**OHIO RIVER BRIDGES  
SECTION 5 - EAST END BRIDGE  
VALUE ENGINEERING STUDY REPORT**

**Item Number 5-118.00**

**VALUE ENGINEERING STUDY  
for  
Kentucky Transportation Cabinet**

**Final Report**

**TYPICAL SECTION - B**  
TOWER LOCATIONS SHOWN, OTHER LOCATIONS SIMILAR  
GRAPHIC SCALE 1" = 10'

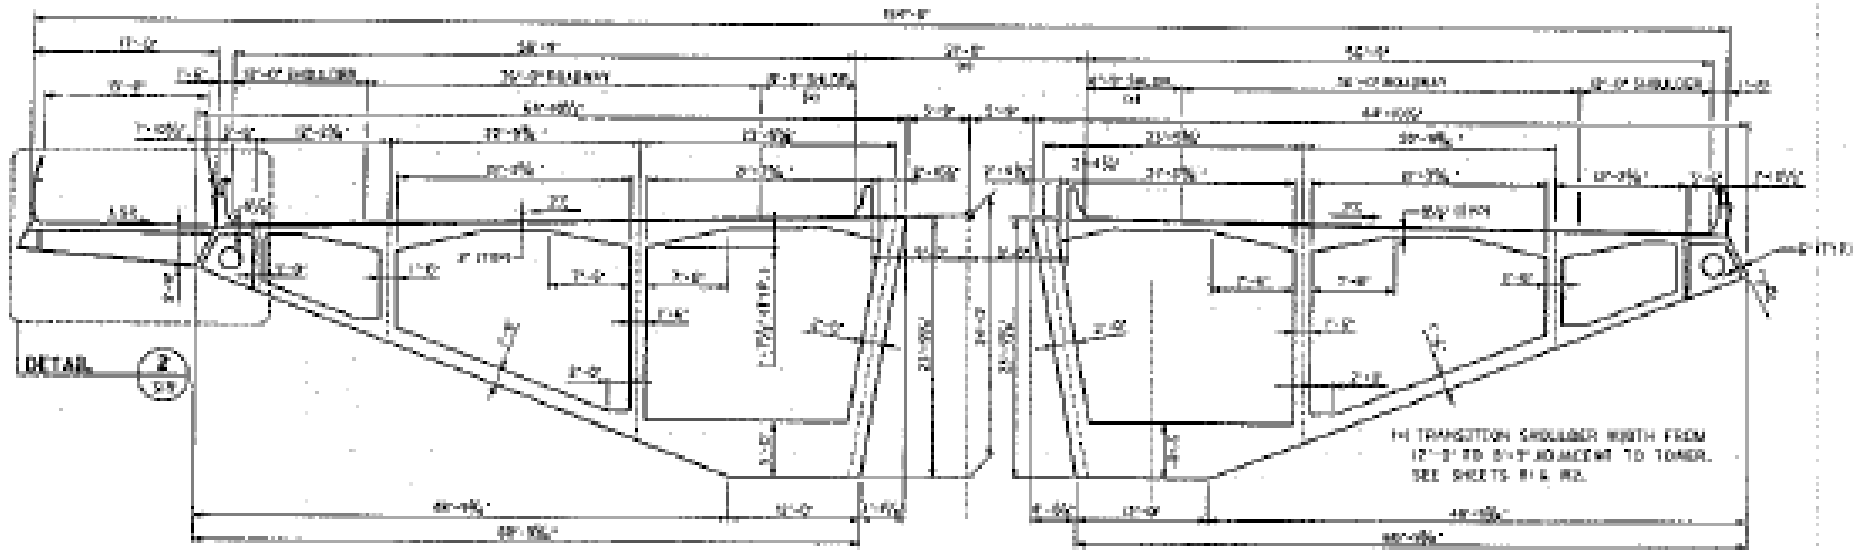
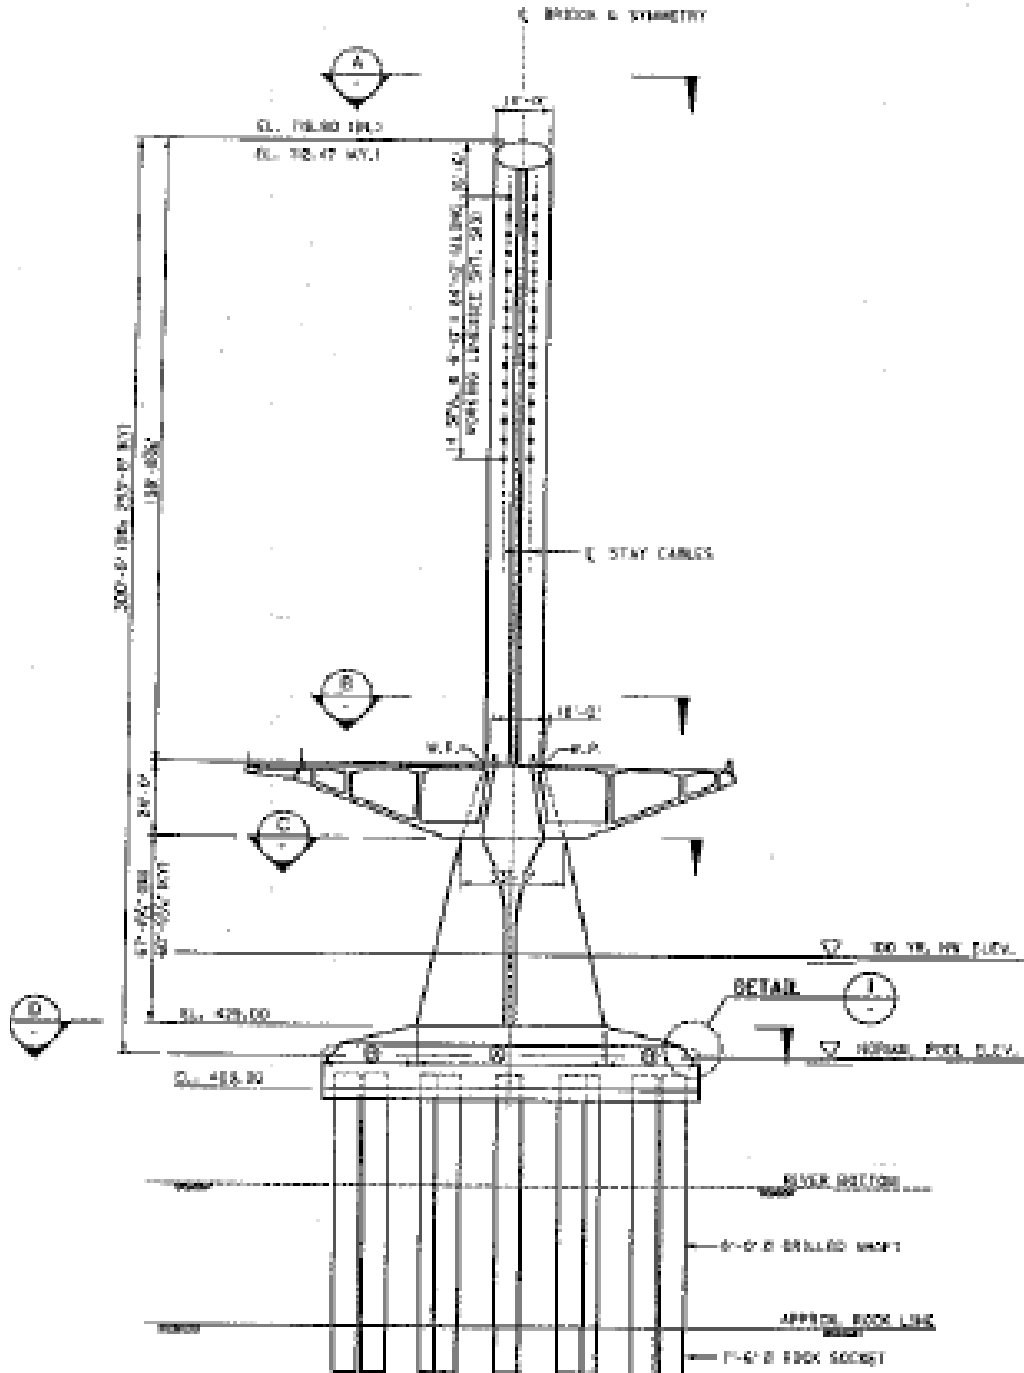
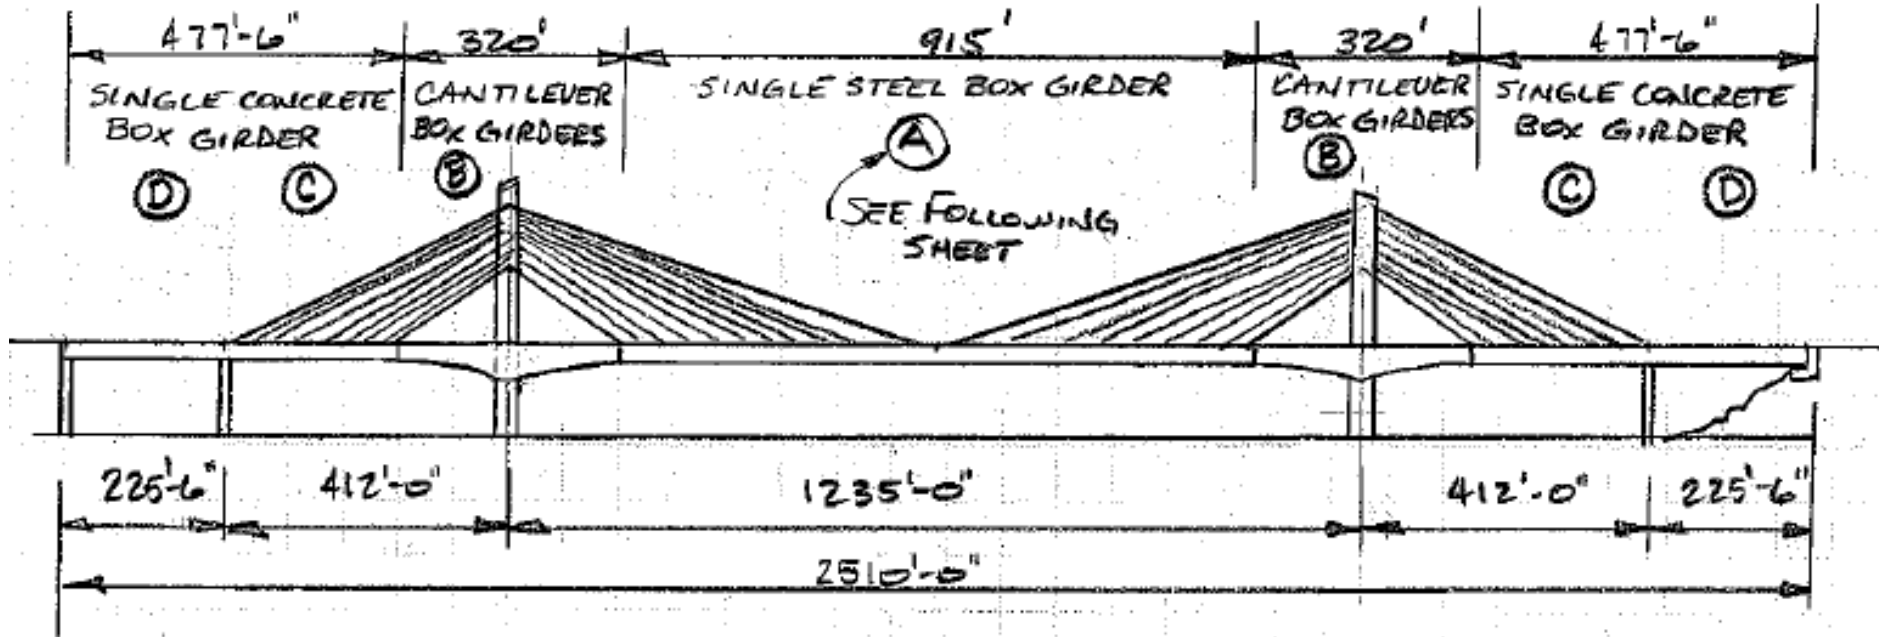
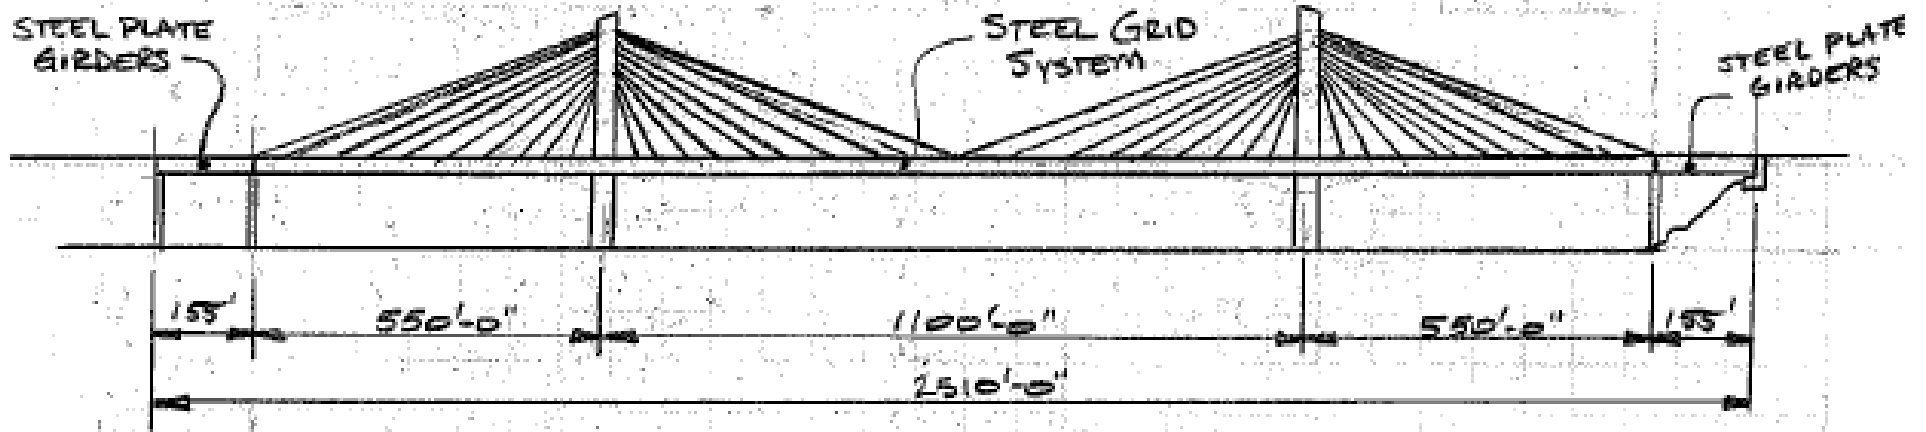
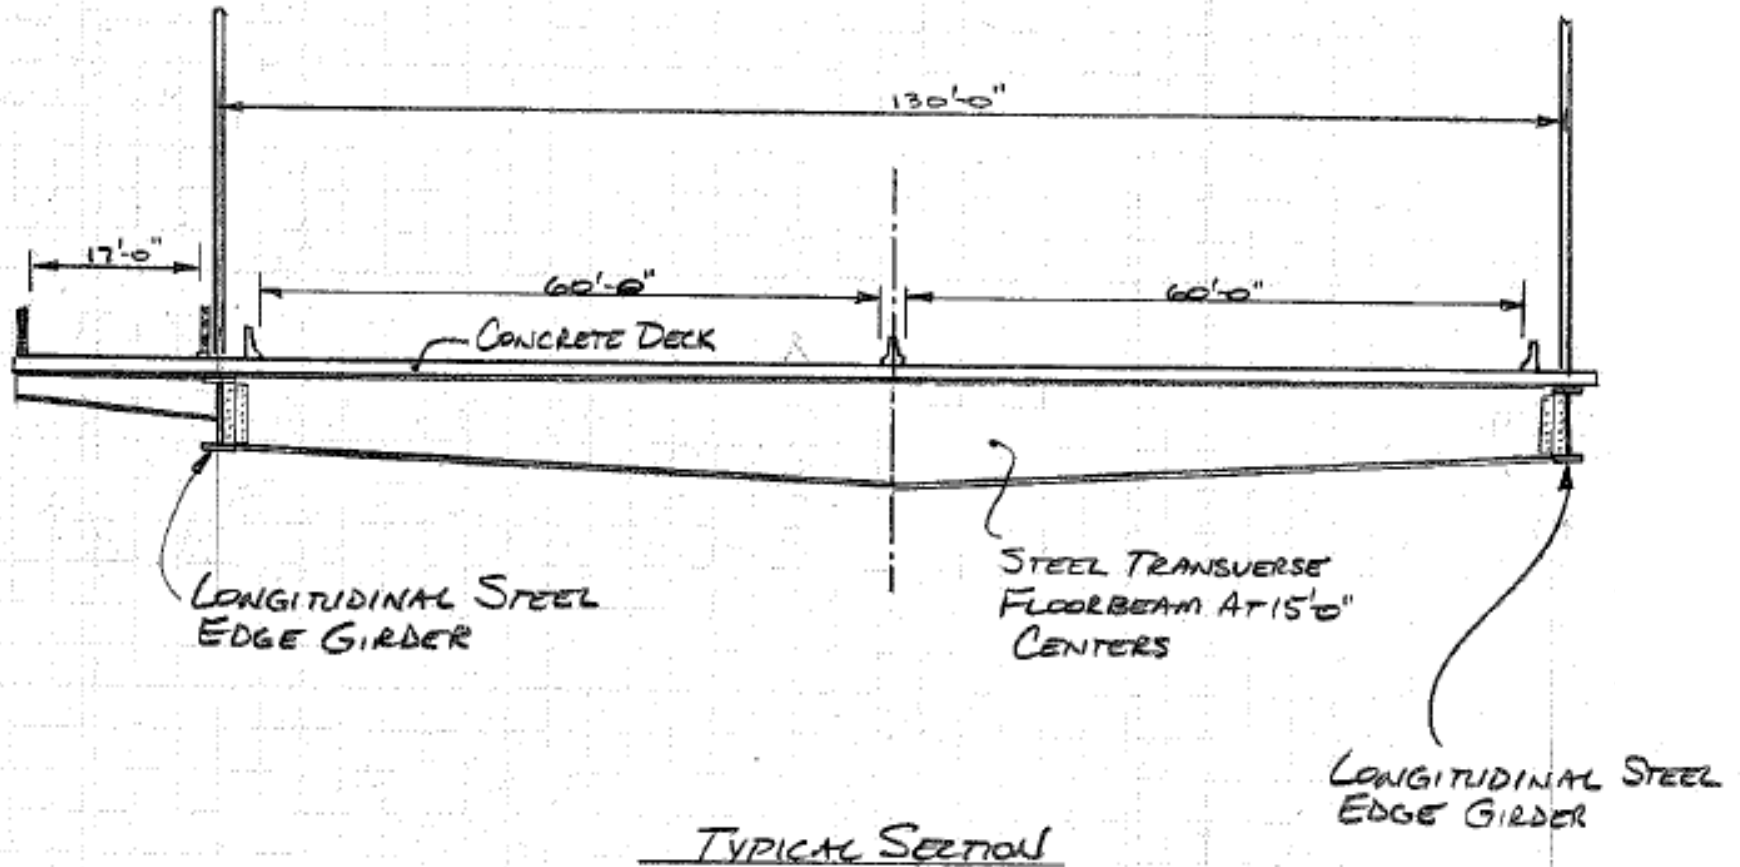
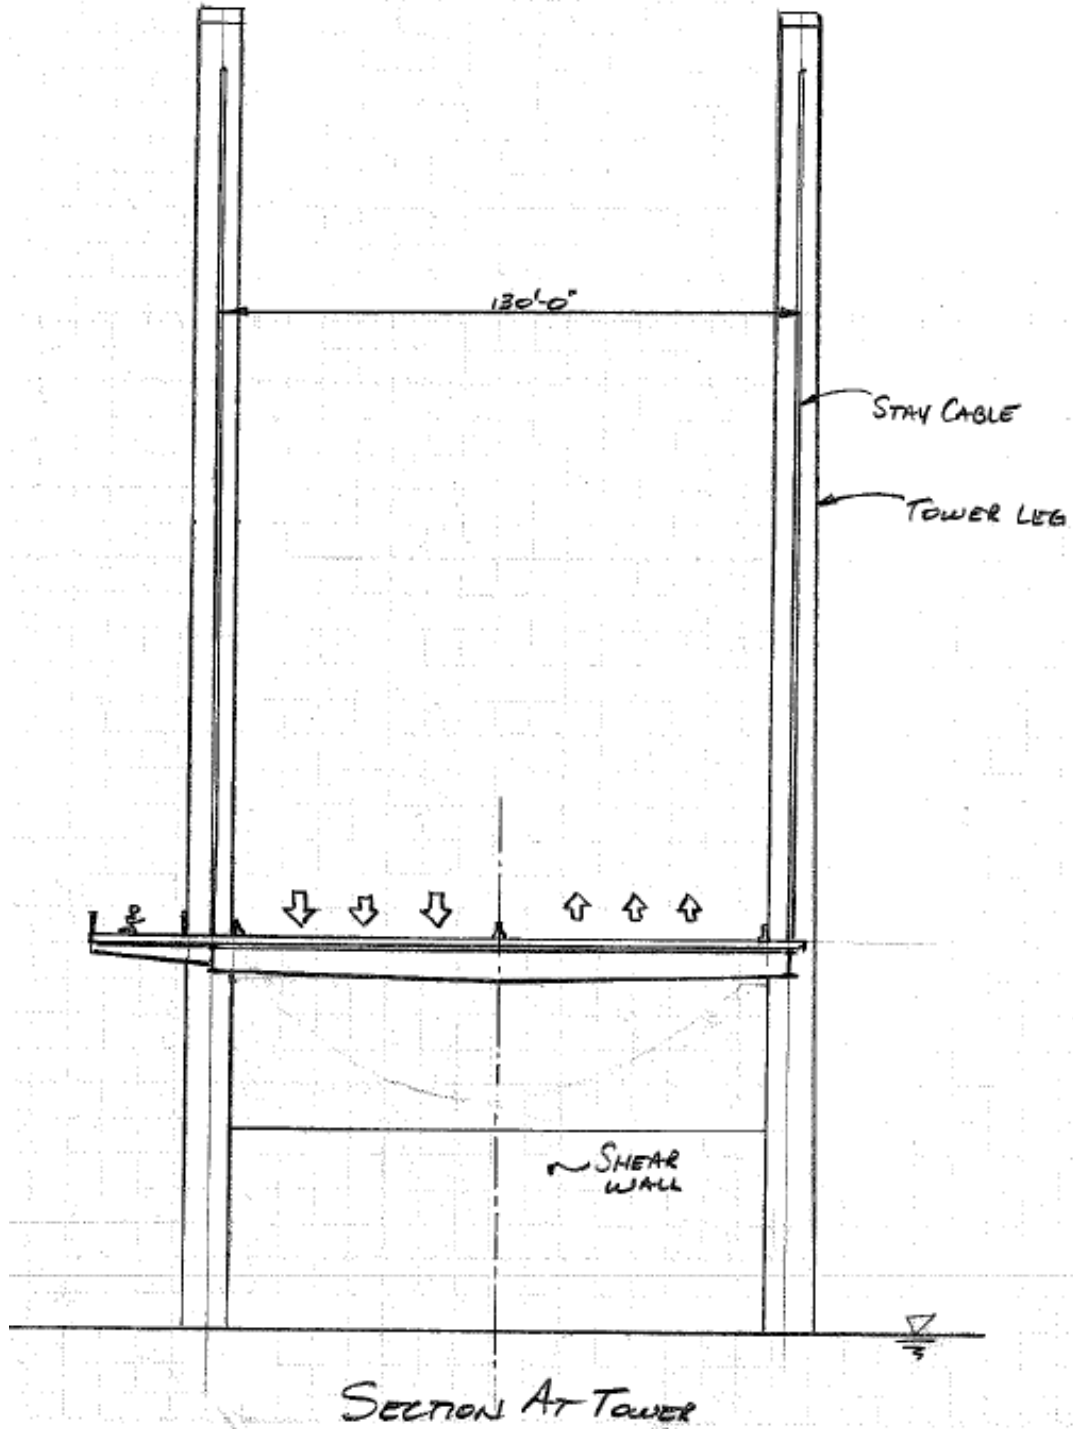
Replace the large concrete and steel box girders that utilize a smooth bottom soffit with a superstructure system utilizing an open grid system of longitudinal edge girders and transverse floorbeams. To facilitate the open grid system with longitudinal edge girders, a plane of stay cables will be required along both edges of the superstructure. Furthermore, towers will be required along each edge of the superstructure to support the two planes of stay cables. The open grid superstructure system is the most economical cable stayed bridge system and can be utilized as a baseline to evaluate the cost premium associated with the original design.

SKETCH OF ORIGINAL DESIGN

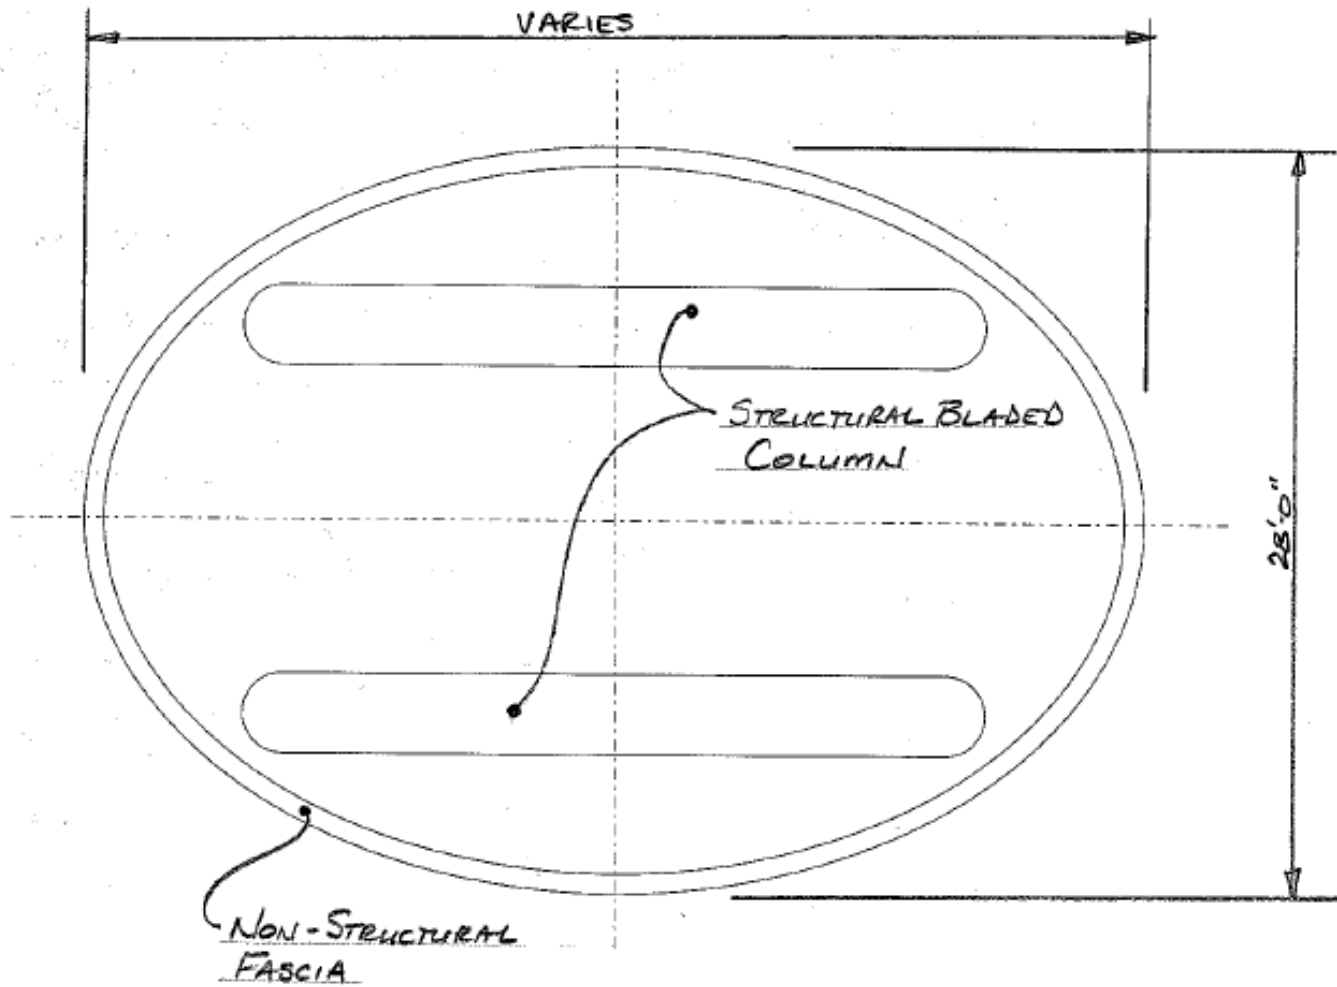
The Preliminary Plans show that the tower legs below deck are thin walled elliptical shapes that measure 28'-0" longitudinally and vary in width from 33'-0" to 60'-0". Additionally, the superstructure is cast integral with the towers at both tower locations.

Since the superstructure is integral with the tower at both locations the foundations will experience large forces from temperature variations because the elliptical tower legs below deck are very stiff flexural elements (28' in depth and only 60' tall). To alleviate the large forces in the foundations from temperature movements it is recommended to replace the closed elliptical shape below deck with twin wall bladed columns. The twin wall bladed columns will allow the superstructure to move longitudinally due to temperature variations with very little demand on the foundations, while still providing excellent restraint of the superstructure rotationally.

If the elliptical shape is desired from an aesthetics standpoint then a non-structural fascia can be added to encompass the twin wall bladed columns.

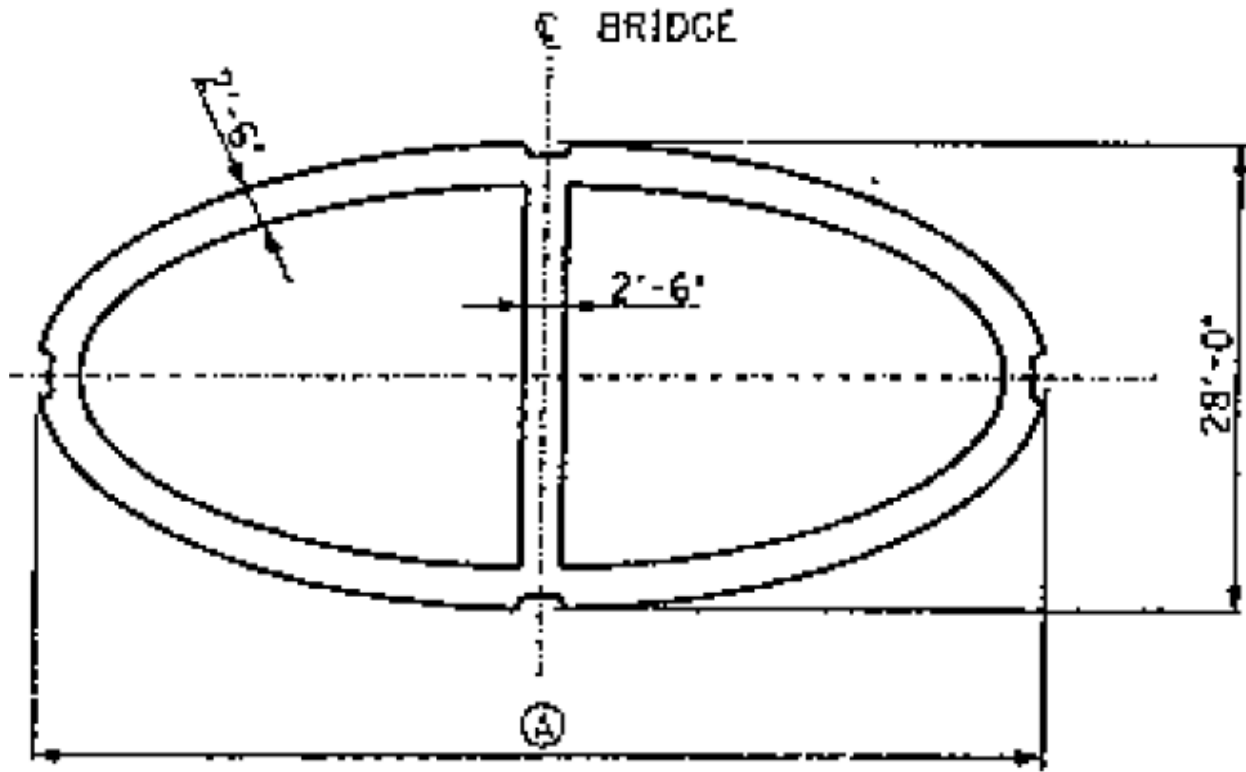
The Preliminary Plans show that the tower legs below deck are thin walled elliptical shapes that measure 28'-0" longitudinally and vary in width from 33'-0" to 60'-0". The top of footing is 10' above normal pool level. The columns within the barge impact zone need to be designed to resist the localized barge impact forces. The thin walled column shape shown in the Preliminary Plans may not be able to resist these large impact forces (6,023 kips) and consideration should be given to providing solid sections within this zone.

According to the Barge Impact Analysis Report (dated November 2007), the fully loaded barge impact force is applied at elevation 421.8, which is 3' above the normal pool elevation. The unloaded barge impact force should be applied at elevation 454.7, which is 3' above the 100 year high water elevation. The recommended impact elevation for the fully loaded barge at the normal pool elevation plus 3' should be re-evaluated in accordance with the AASHTO Guide Specification and Commentary for Vessel Collision Design of Highway Bridges. Generally, fully loaded barges will utilize the river at all water elevation until the locks are closed; therefore, the impact force application elevation should take this into account. On recent cable stayed projects over the Ohio River (Pomeroy-Mason, U.S. Grant and Ironton-Russell) the fully loaded barge impact forces are applied 2' above the mean high water level (often taken as the 2% flow line). This will be substantially higher than the normal pool level recommended in the Barge Impact Analysis Report.

If the recommendations of Design Comment 4 are incorporated and bladed columns with an elliptical fascia are utilized for the tower legs below deck, then the space between the elliptical fascia and the structural blades can be filled with low grade concrete to provide barge collision resistance as long as an adequate gap is provided completely around the blades to allow the blades to flex independent of the elliptical fascia and fill concrete.
